## Product / Process Change Notification (PCN)

**PCN #:** PCN\_UtLAN\_20240411  
**Affected Series:** WE-LAN-Series; 7490xxx  
**PCN Date:** January 11, 2024  
**Effective Date:** April 11, 2024

Due to external influences, Würth Elektronik will change to another existing production line to manufacture following parts, the design and process will be changed along.

**Affected P/N:** 749010012A, 7490100161A, 749013011A, 749090010A, 749090012A, 749010017A

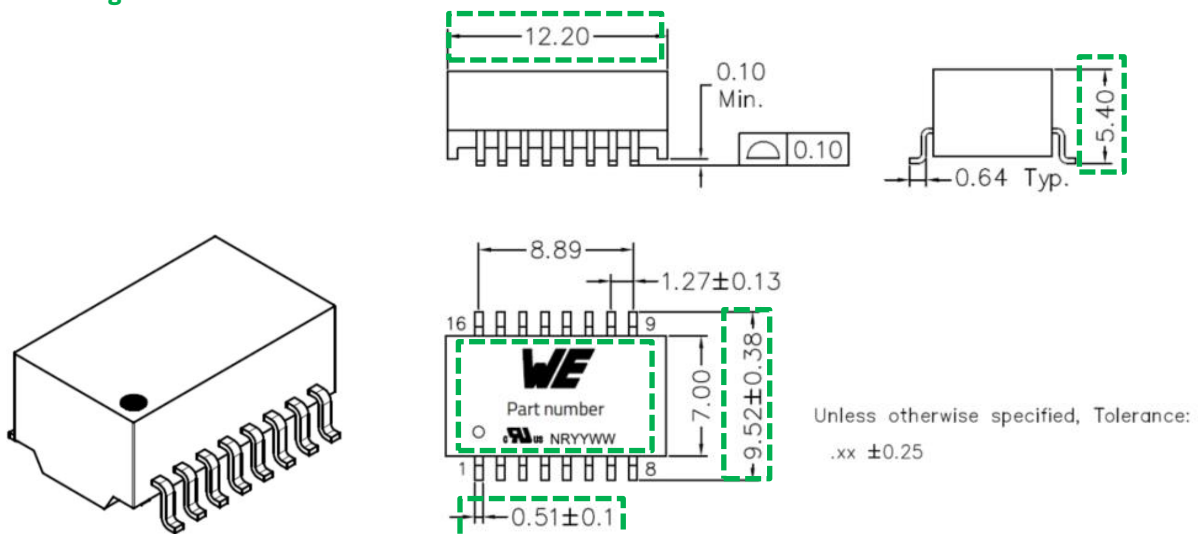
#### 4, Product drawing and marking.

A	12,7 ± 0,25	mm
B	6,35 max.	mm
C	9,40 ± 0,25	mm
D	8,80 ± 0,25	mm
E	1,20 ± 0,05	mm
F	1,27 ± 0,05	mm
G	0,30 ± 0,10	mm
a	6,80 ± 0,25	mm
b	2,40 ± 0,25	mm
c	1,55 max.	mm

**Affected P/N:** 7490100160

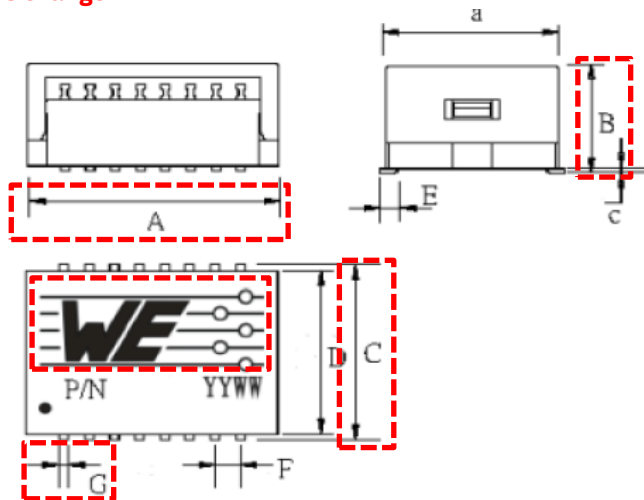
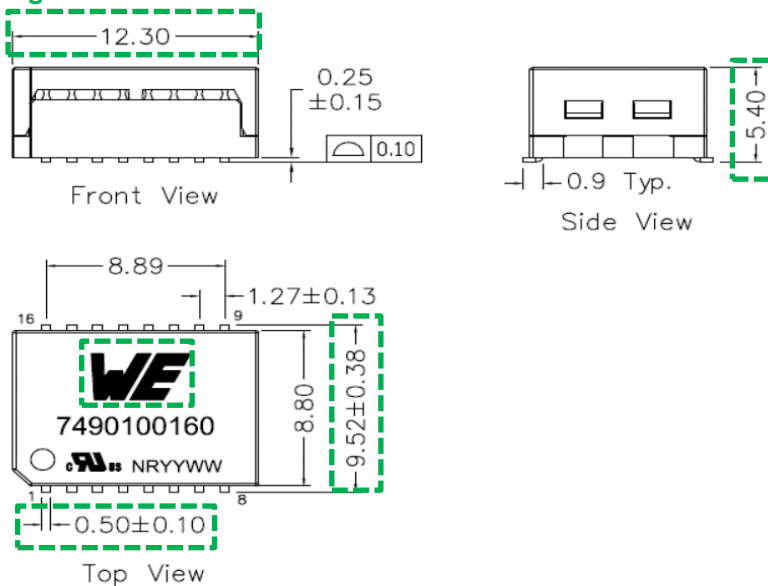
A	$12,70 \pm 0,5$	mm
B	$5,60 \pm 0,5$	mm
C	$9,34 \pm 0,5$	mm
D	$8,70 \pm 0,5$	mm
E	$0,97 \pm 0,15$	mm
F	$1,27 \pm 0,15$	mm
G	$0,46 \pm 0,15$	mm
a	$8,70 \pm 0,5$	mm
c	$0,25 \pm 0,15$	mm

**Affected P/N: 7490100401**

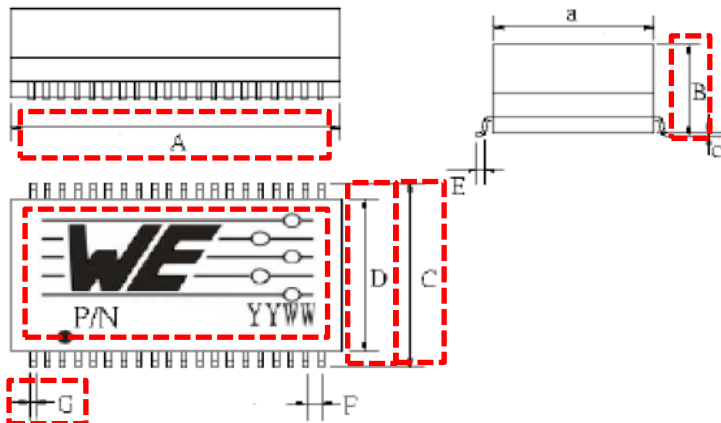
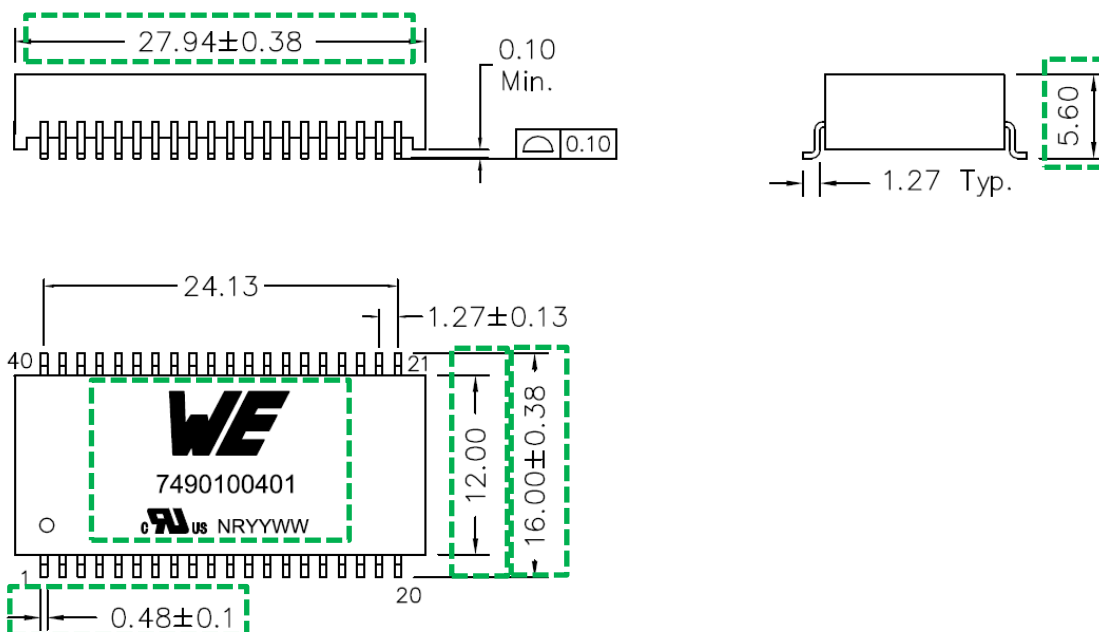
A	$27,55 \pm 0,50$	mm
B	$8,00 \pm 0,50$	mm
C	$16,10 \pm 0,50$	mm
D	$13,84 \text{ max}$	mm
E	$0,75 \pm 0,15$	mm
F	$1,27 \pm 0,10$	mm
G	$0,46 \pm 0,10$	mm
a	$13,84 \text{ max}$	mm
c	$0,25 \pm 0,15$	mm

**Affected P/N:** 749010040A

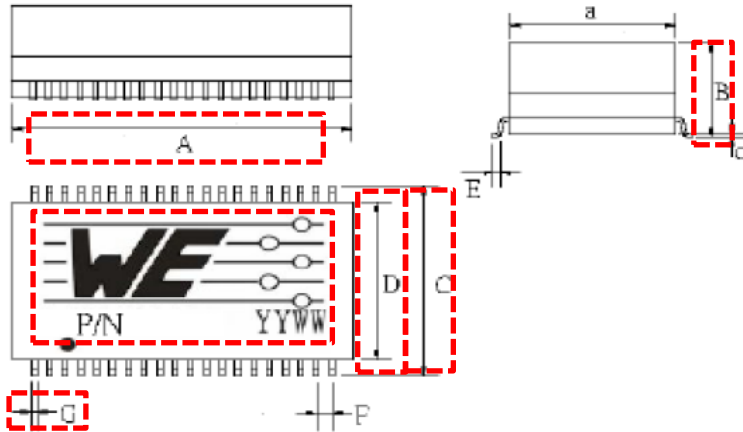
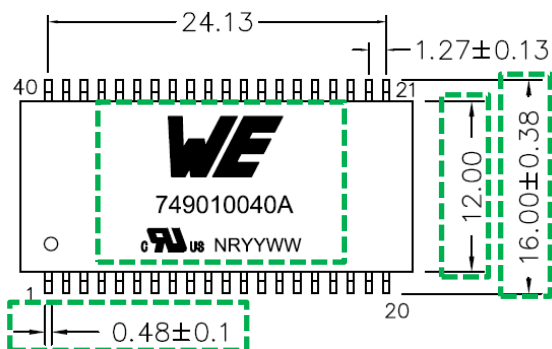
A	$28,10 \pm 0,5$	mm
B	6,20 max.	mm
C	$16,10 \pm 0,50$	mm
D	$11,90 \pm 0,50$	mm
E	$1,05 \pm 0,15$	mm
F	$1,27 \pm 0,10$	mm
G	$0,46 \pm 0,10$	mm
c	$0,25 \pm 0,15$	mm

**Affected P/N:** 7490200141, 749020023A, 7490200143, 749023113A

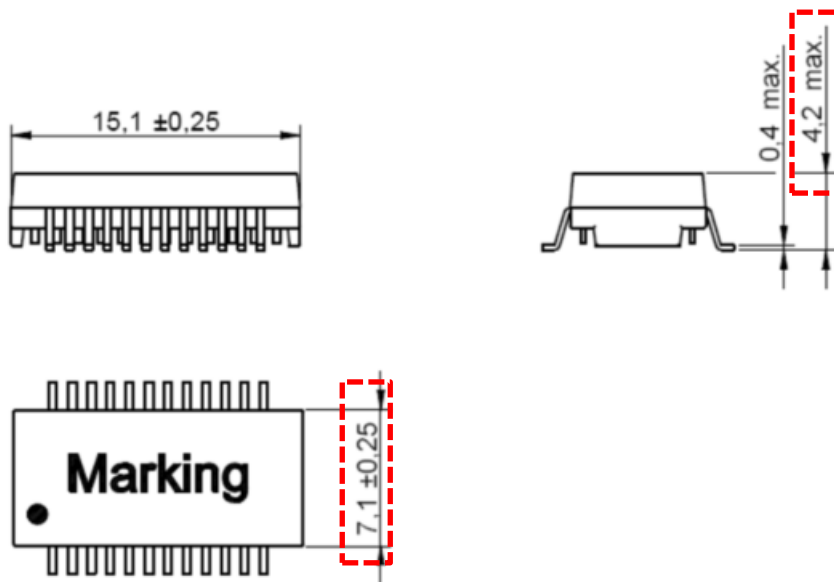
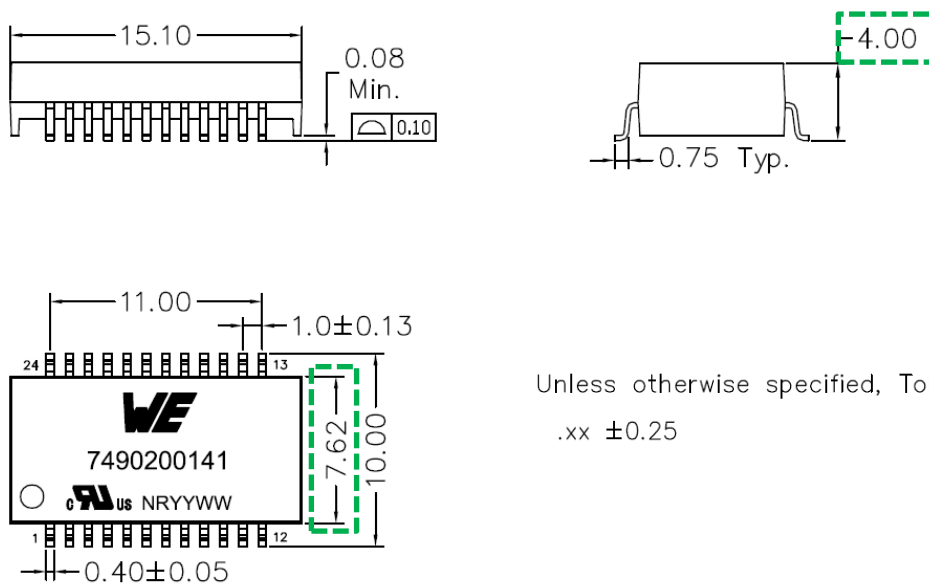
Unless otherwise specified, Tolerance:  
 .xx ±0.25

### 5, Recommended land pattern.

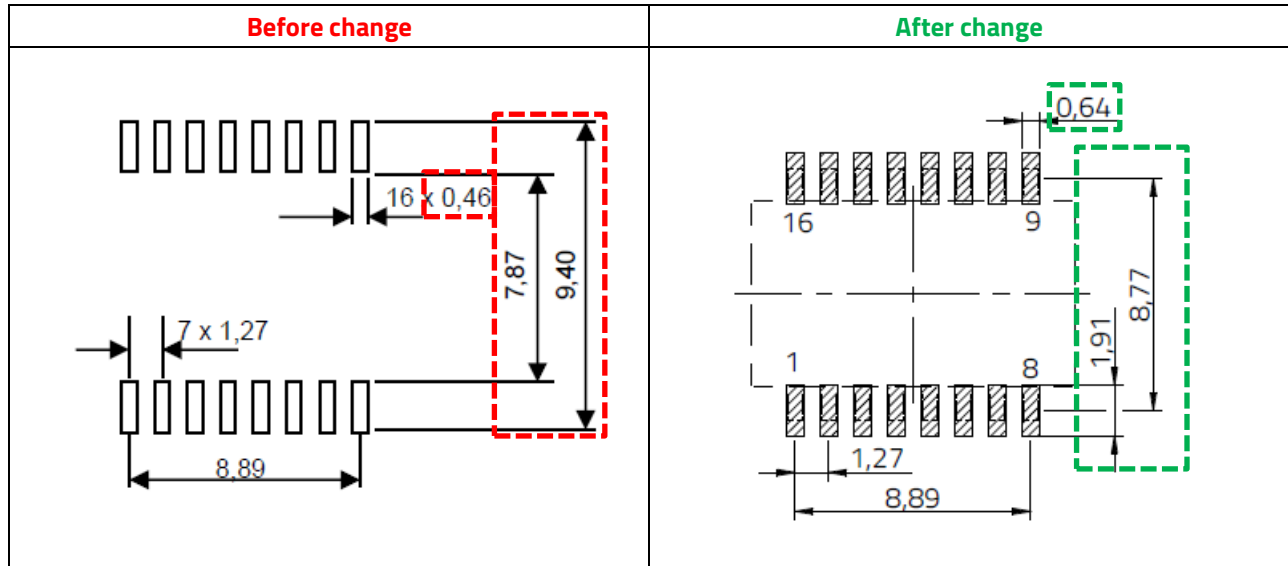
Affected part number: 749090010A, 749090012A
